# COMMONWEALTH of VIRGINIA

## MEMORANDUM

To: All Holders of the Virginia Department of Transportation's 2008 Road and Bridge Standards

The following is a list of sheets contained in the 2008 Road and Bridge Standards that have been revised. Please add these pages to your copy of the standards. An interim standard sheet will not be required in plan assemblies for the following sheets only. Changes to these sheets will not affect the basis of payment or estimates.

201.08

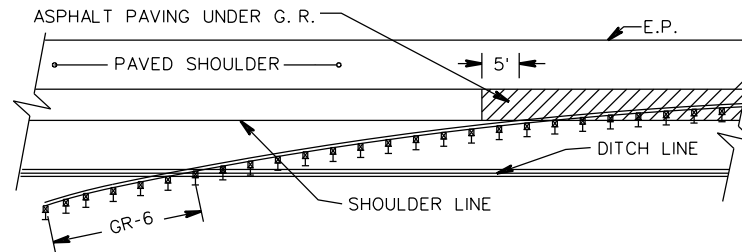
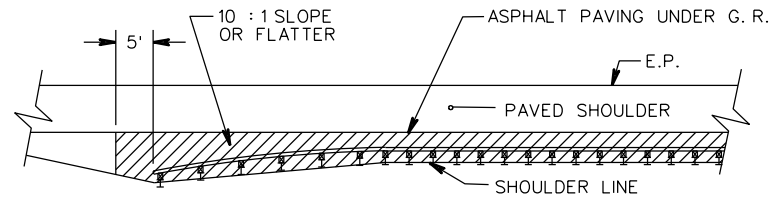
<u>PAGE</u>	<u>INTERIM</u>	<u>STANDARD</u>	<u>REVISION</u>
201.08	IIS02_06	MC-4	CLARIFIED THE SECTION DETAIL TO SHOW THE DIFFERENCE IN THE PAVED SHOULDER DEPTH AND THE PAVING UNDER GUARDRAIL DEPTH

1. TO BE CONSTRUCTED WITH THE SAME MATERIAL AND TO THE SAME DEPTH AS THE ROADWAY PAVED SHOULDER.
2. TO BE CONSTRUCTED WITH THE SAME ASPHALT MATERIALS AS THE PAVED SHOULDER TO THE FOLLOWING DEPTHS:

ALLOWABLE DEPTHS OF ASPHALT MATERIAL	
IM-19.0A OR IM-19.0D	2" MIN
BM-25.0	3" MIN
3. DEPTH OF ASPHALT MATERIAL MAY BE EXTENDED AT THE CONTRACTOR'S OPTION TO COINCIDE WITH THE BOTTOM OF THE PAVED SHOULDER COURSE AT NO INCREASE IN THE QUANTITY OF ASPHALT MATERIAL COMPUTED USING THE ABOVE SPECIFIED DEPTH.
4. ADDITIONAL 5 FEET ASPHALT PAVING BEYOND POINT WHERE GUARDRAIL CROSSES SHOULDER LINE.
5. FOR ADDITIONAL DESIGN AND PLACEMENT INFORMATION SEE SHEET 1 OF 2.

300.01

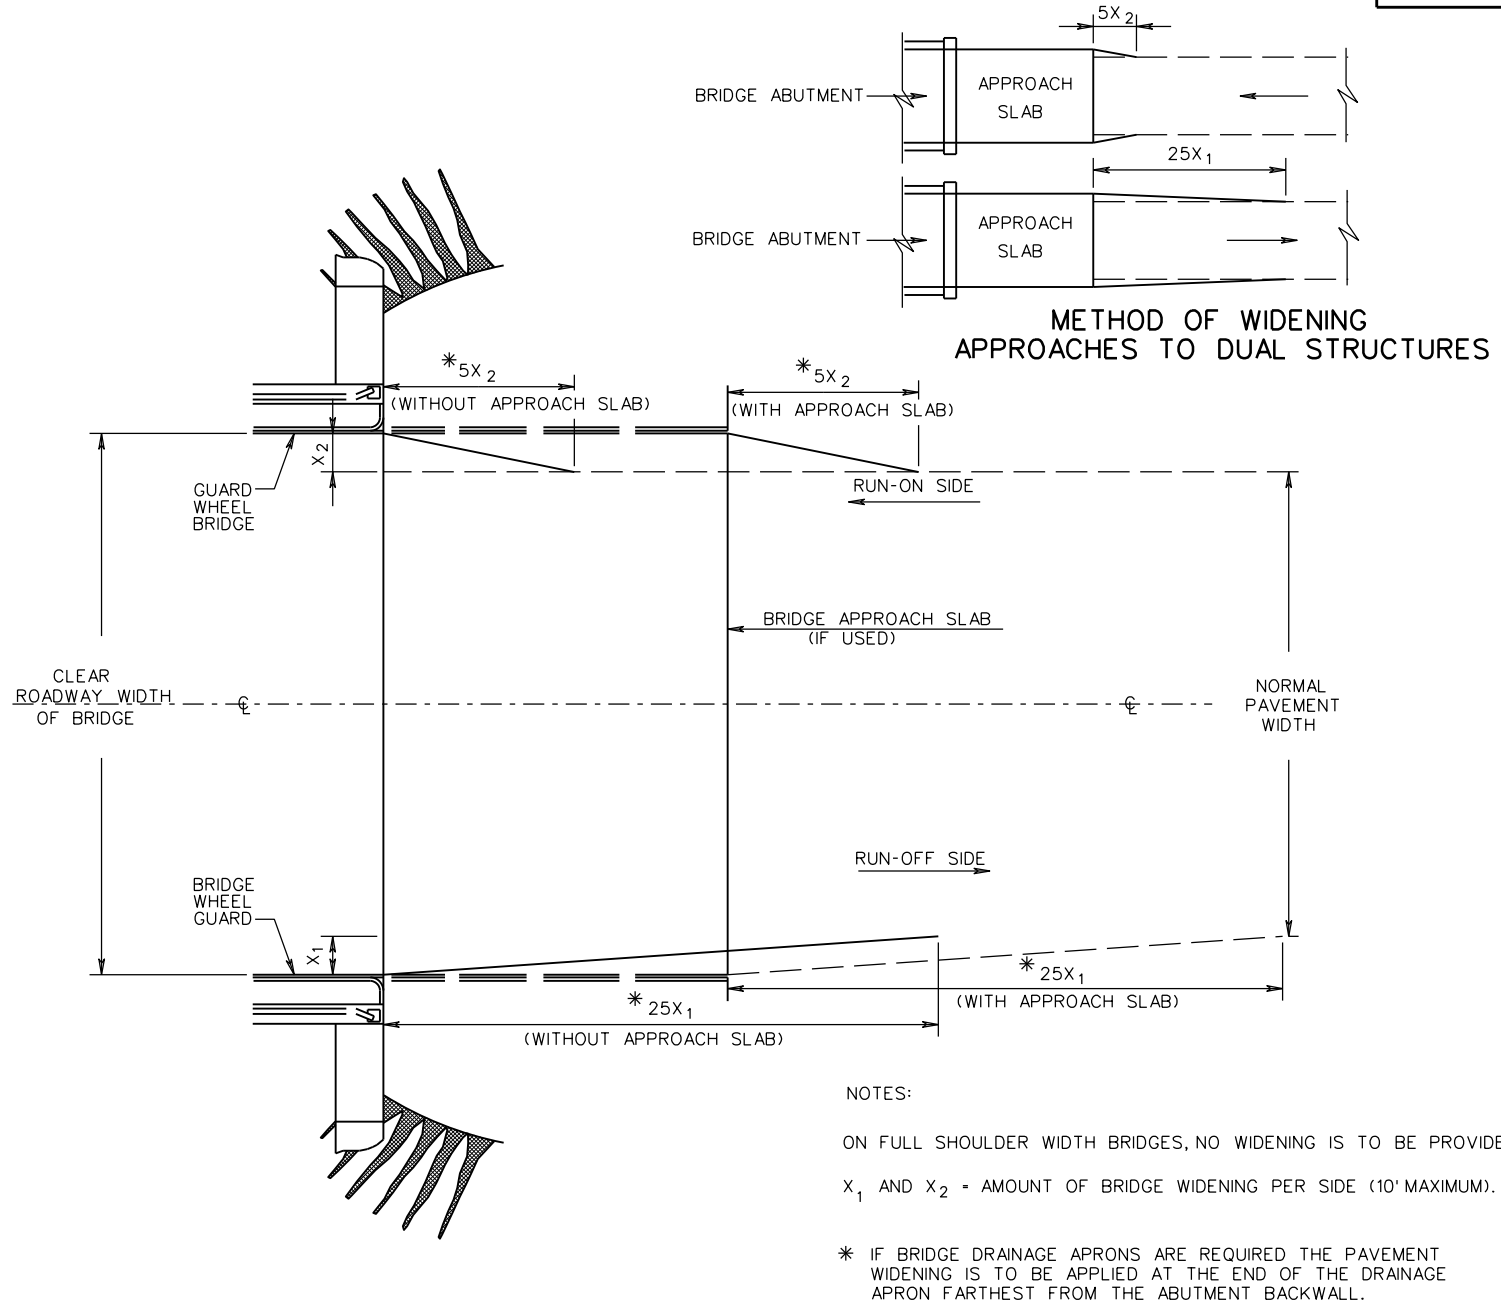
<u>PAGE</u>	<u>REVISION</u>
300.01	Revised index voiding page 303.01 Standard WP-1
303.01	Void - Standard WP-1 Method of Widening Bridge Approach Pavement
503.02	Corrected center detail for Metal Post to show the 6" dimension from the top of post to the top of the fence.

304.02

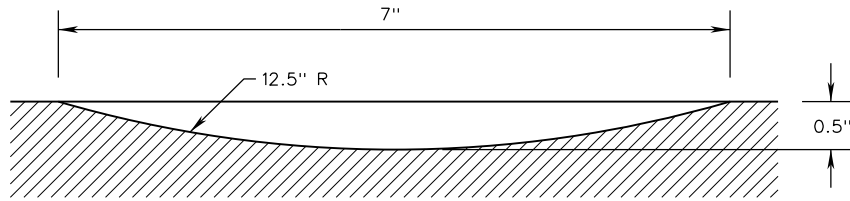
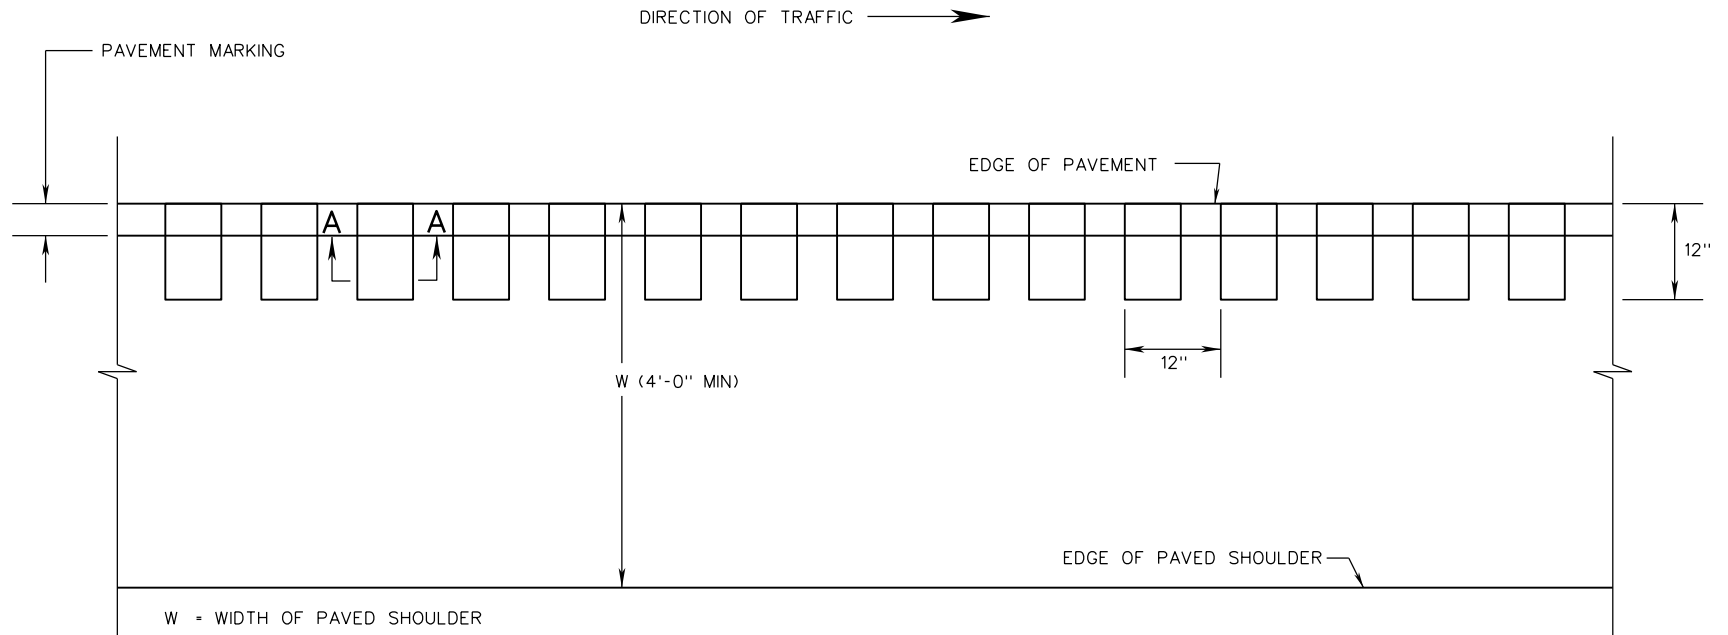
<u>PAGE</u>	<u>INTERIM</u>	<u>STANDARD</u>	<u>REVISION</u>
304.02	IIS03_04	RS-3	REVISED NOTE 7 REMOVED STATEMENT " <i>IN ASPHALT CONCRETE PAVEMENT THAT IS BEEN IN PLACE MORE THAN ONE YEAR</i> ".
304.03	IIS03_05	RS-4	REVISED NOTE 4 REMOVED STATEMENT " <i>IN ASPHALT CONCRETE PAVEMENT THAT IS BEEN IN PLACE MORE THAN ONE YEAR</i> ".
502.01	IIS05_18	MB-3	REVISED FLARE RATE TABLE TO MATCH THE RDM AND AASHTO
1005.10	1005.10	BCQ-10	UPDATED SHEET TO SHOW WINGWALL DESIGNATIONS
1324.10	IIS13_04	OSS-1	THE ELEVATION DRAWINGS WERE UPDATED INCREASING THE PROJECTION ABOVE GRADE FOR FOUNDATIONS AND NOTE 7 AND 8 WERE ADDED
1324.13	IIS13_41	OSS-1	FOOTING DETAIL UPDATED INCREASING THE PROJECTION ABOVE GRADE FOR FOUNDATIONS

7. FOLLOWING CUTTING AND CLEANING DEPRESSIONS OF WASTE MATERIAL, THE ENTIRE RUMBLE STRIP AREA SHALL BE COATED WITH LIQUID ASPHALT COATING (EMULSION) USING A PRESSURE DISTRIBUTOR AT AN APPROXIMATE RATE OF 0.1 GALLON PER SQUARE YARD. OVERSPRAY SHALL NOT EXTEND MORE THAN 2 INCHES BEYOND THE WIDTH OF CUT AND/OR SHALL NOT COME IN CONTACT WITH PAVEMENT MARKINGS.
